1 P802.11wTM/D2.12
2

22
23
24 Amendment ~~<number>~~ 5 : Protected Management
25 Frames
26
27
28
29
30
31
32

33 *EDITORIAL NOTE - In this redline version of the draft, inserted text is shown as Inserted Text and deleted text is*
34 *shown as Deleted Text.*
35

Figure 5-13—Establishing pairwise and group keys

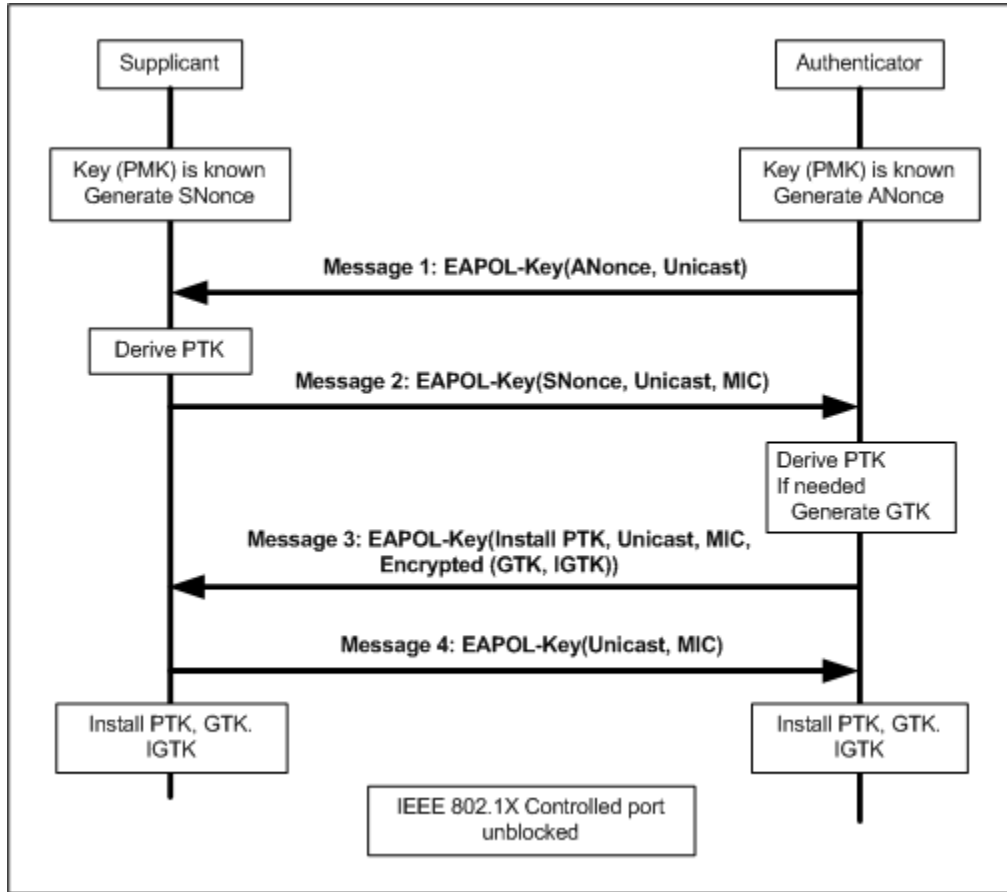
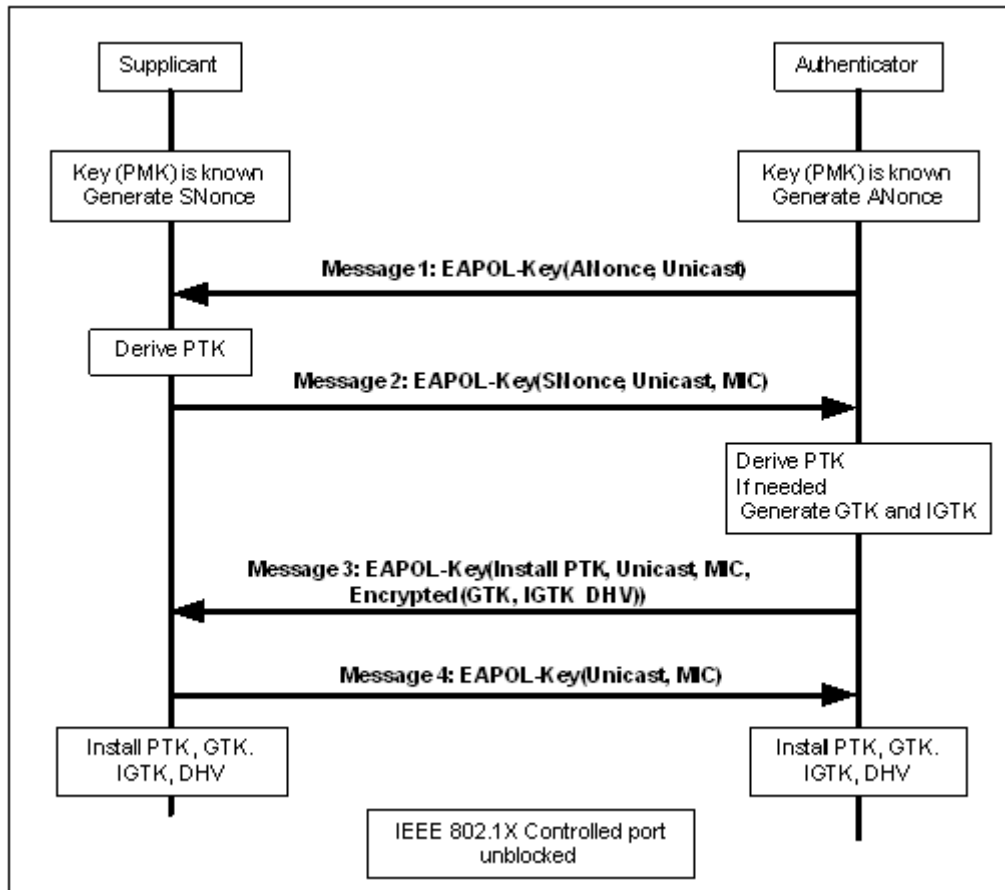
1 *Replace Figure 5-13 with the following figure, with the changes being the inclusion of “IGTK” in mes-*
2 *sage 3 and in both the Supplicant and Authenticator boxes that begin with “Install” and in the Authenti-*
3 *cator box to “Generate GTK and IGTK”:*
4
5
6

Figure 5-14 — Delivery of subsequent group keys

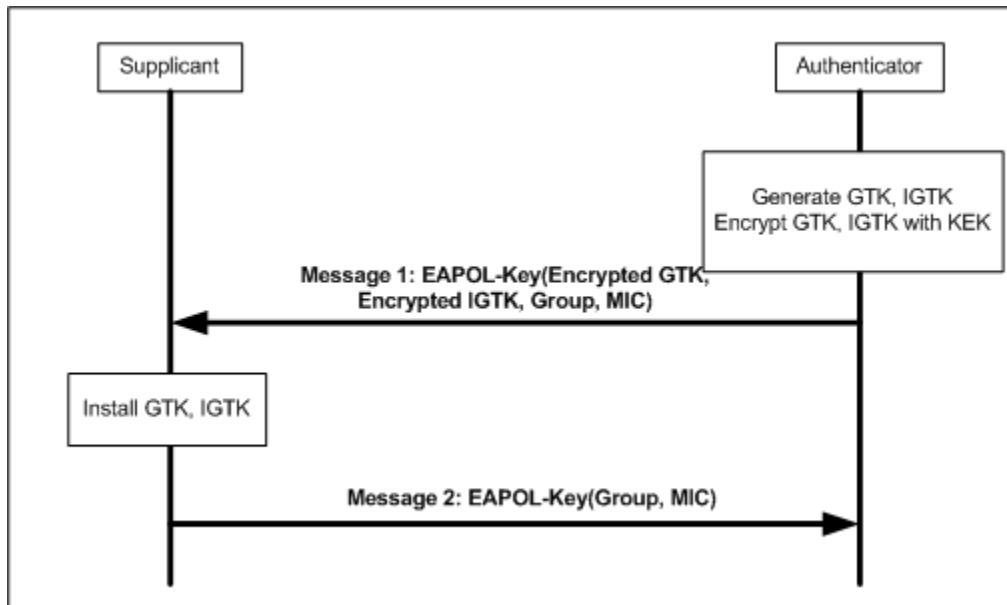
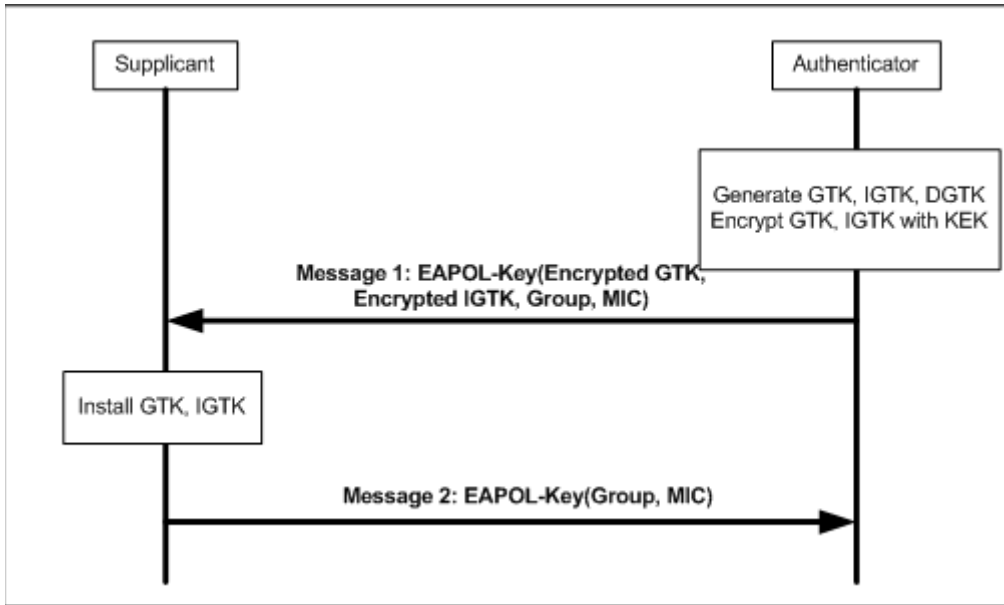
1 *Replace Figure 5-14 with the following figure, with the changes being the inclusion of “Encrypted*
 2 *IGTK” in Message 1, “IGTK” in the Authenticator box beginning with ‘Generate” and “IGTK” in the*
 3 *Supplicant box beginning with “Install”;* the update to the 2nd box on the right has *intentionally-intention-*
 4 *ally fixed from the 802.11ma D9.0 draft 11-2007 to correctly state “Encrypt GTK, IGTK with KEK”:*
 5
 6
 7
 8

Figure 8-18 — Nonce Construction

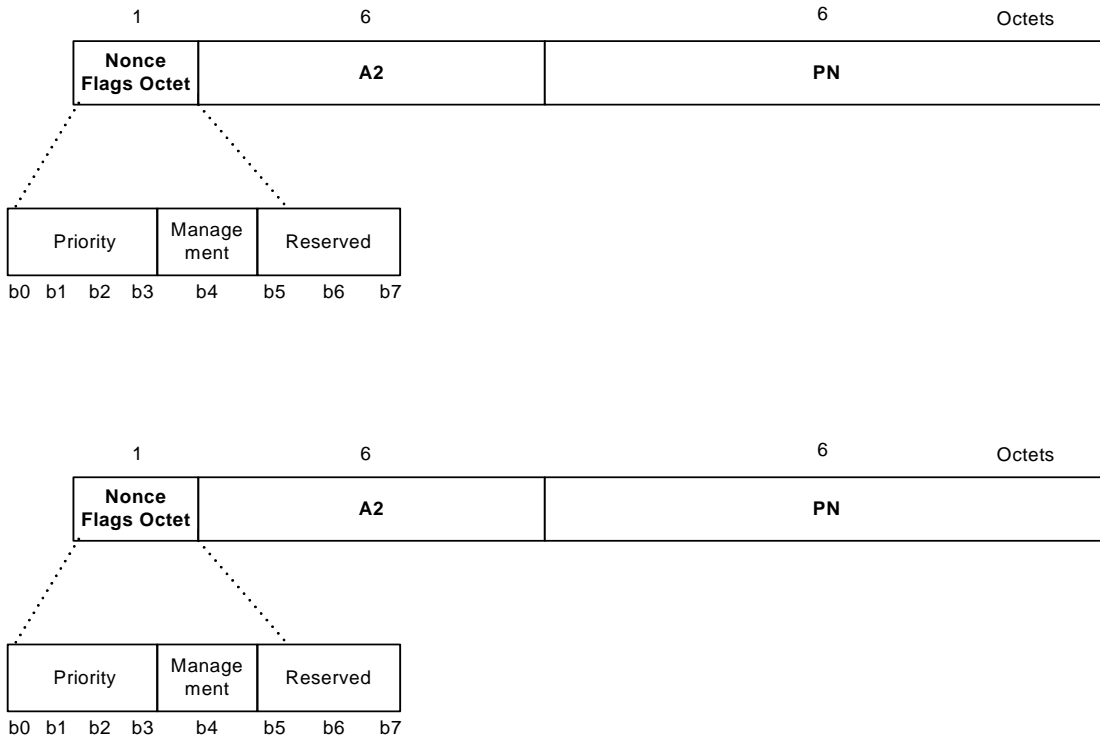
61
62
63 *Replace Figure 136 with the following figure ~~replacing "Priority Octet" with "Nonce Flag Octet", and~~*
64 *addition of "Management" as bit 4 of this octet."*
65

Figure 8-33—Sample 4-Way Handshake

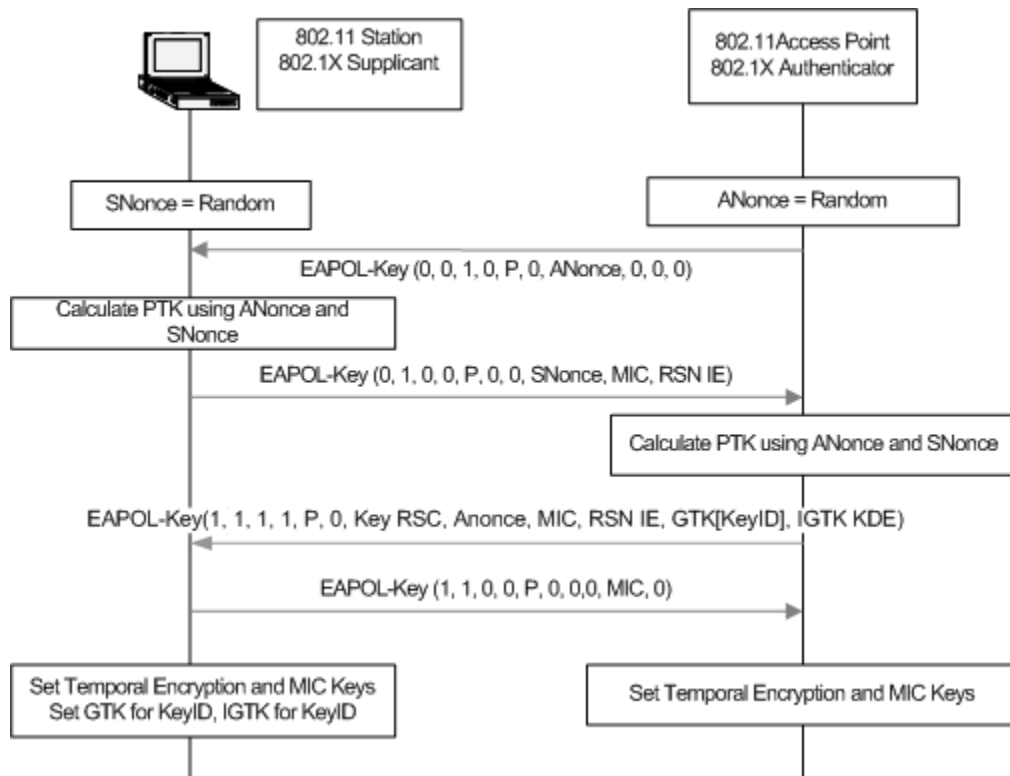
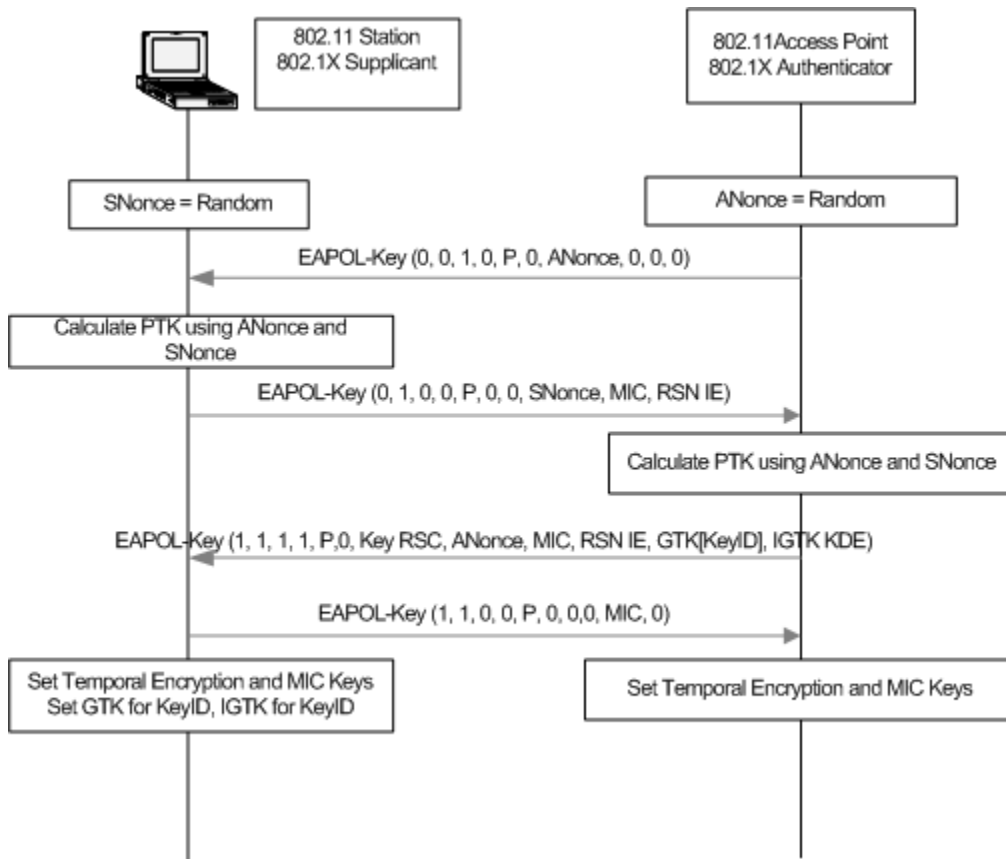
Replace Figure 151 with the following Figure, with the ~~updated~~ updates including IGTK KDE on the 3rd EAPOL-Key message and "IGTK Key ID" on the 3rd supplicant box:

Figure 8-34—Sample Group Key Handshake

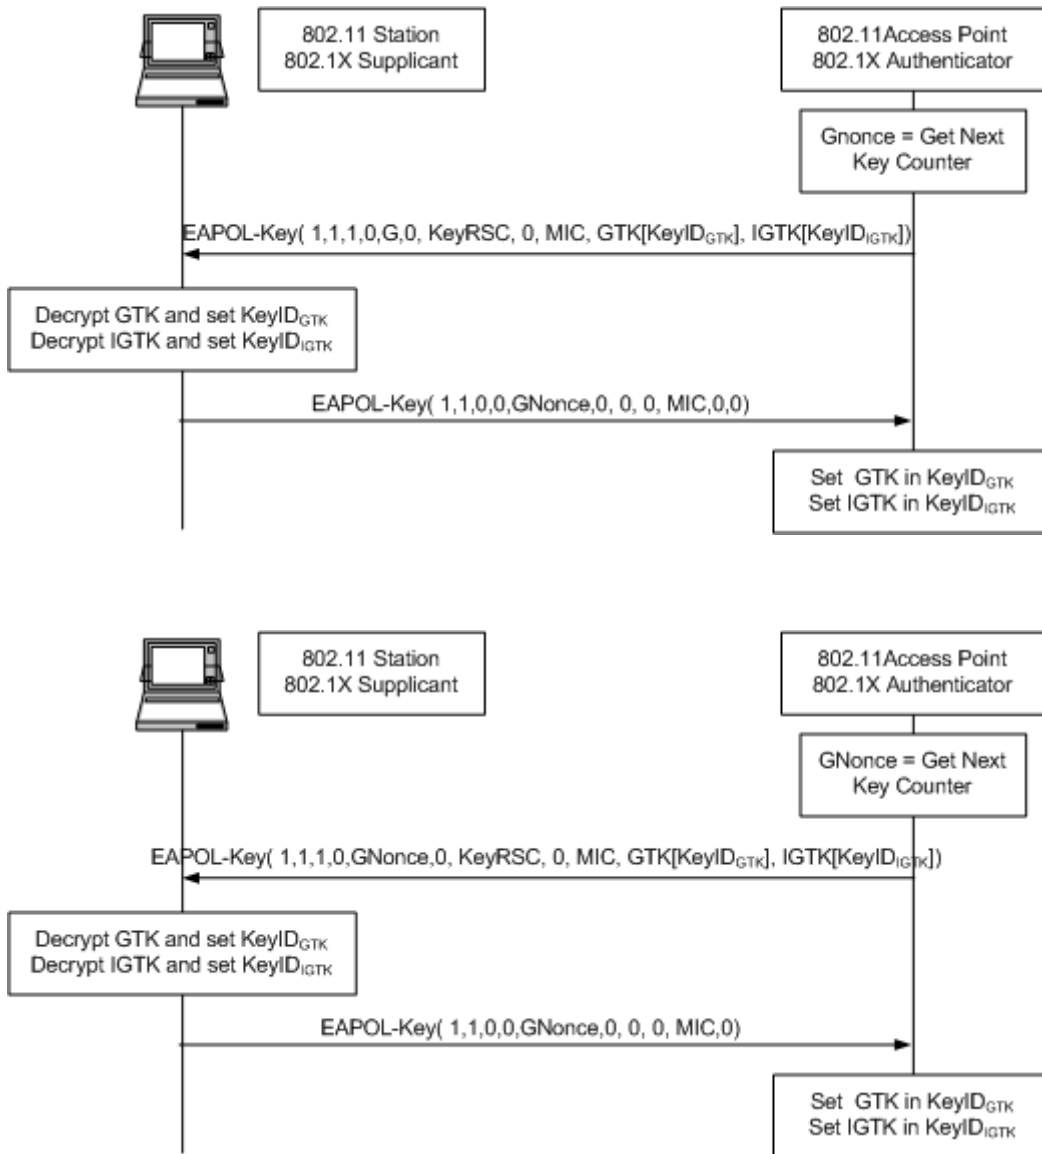
1 *Replace Figure 152-8-34 with the following Figure, with the updated updates including IGTK on the first*
 2 *EAPOL-Key message and 2nd supplicant box, adding "0,0" on reformatting the first message above the*
 3 *second EAPOL-Key message arrow and IGTK and new subscripts to the last Authenticator box:*
 4
 5
 6
 7

Figure 8-35—RSNA Supplicant key management state machine

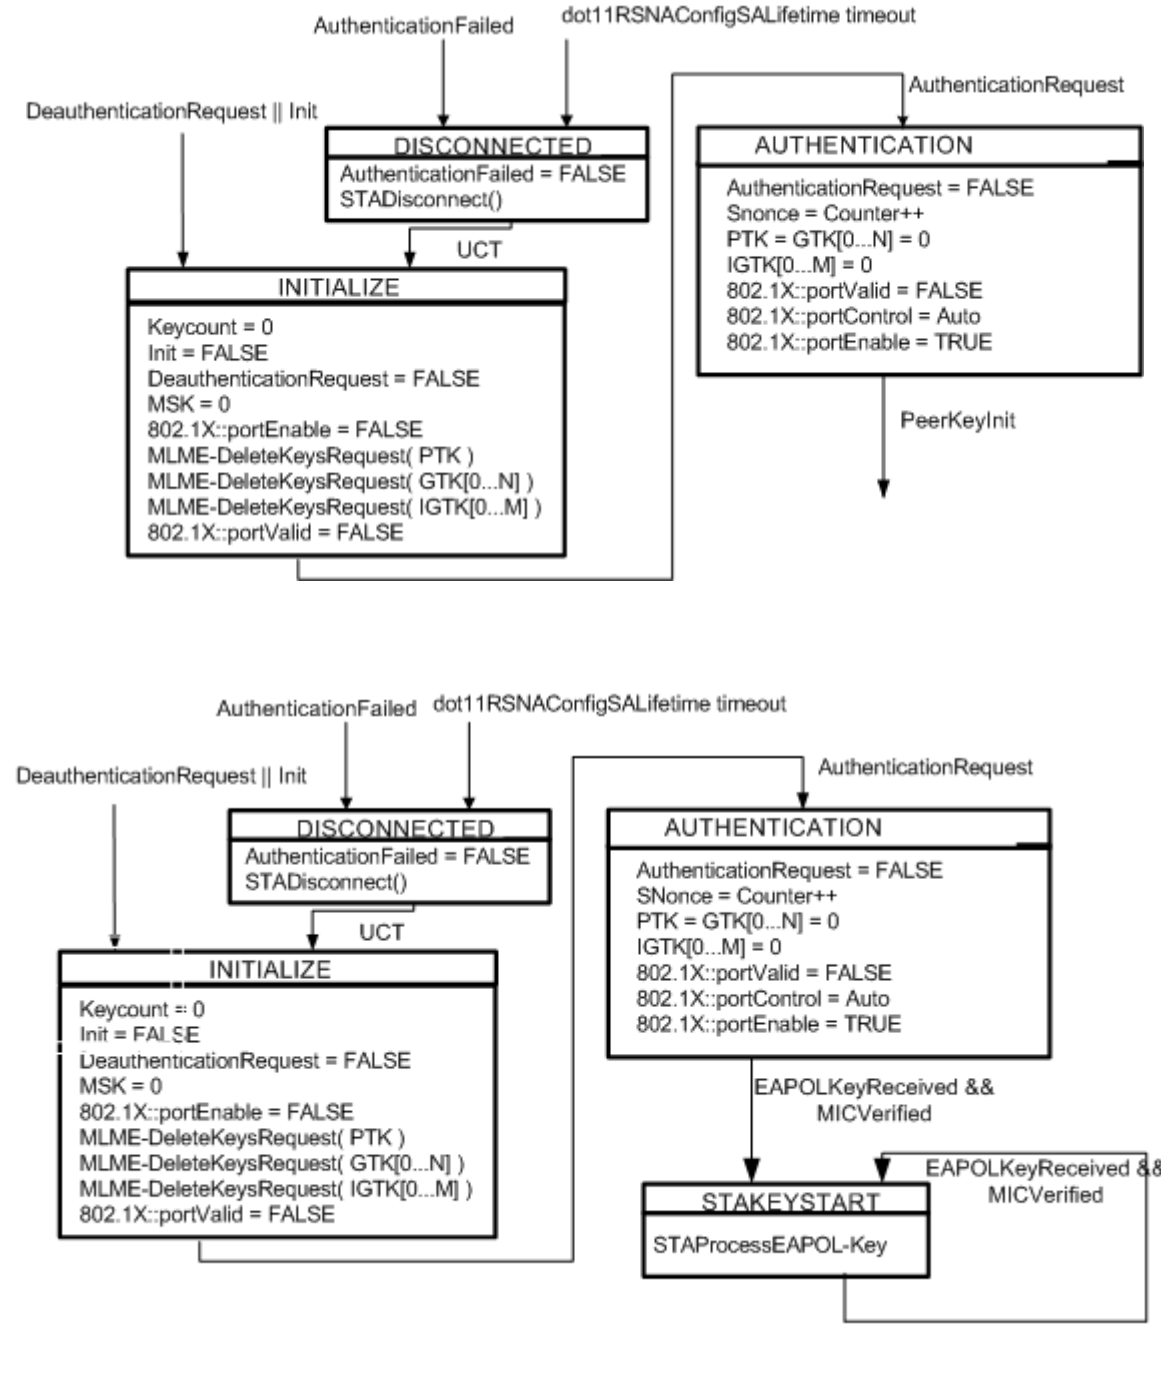
Replace Figure 153-8-35 with the following figure updating “Snonce” to “SNonce”, adding “IGTK[0...M] = 0” in the “AUTHENTICATION” box and “MLME-DeleteKeysRequest(IGTK[0...M])” to the “INITIALIZE” box:
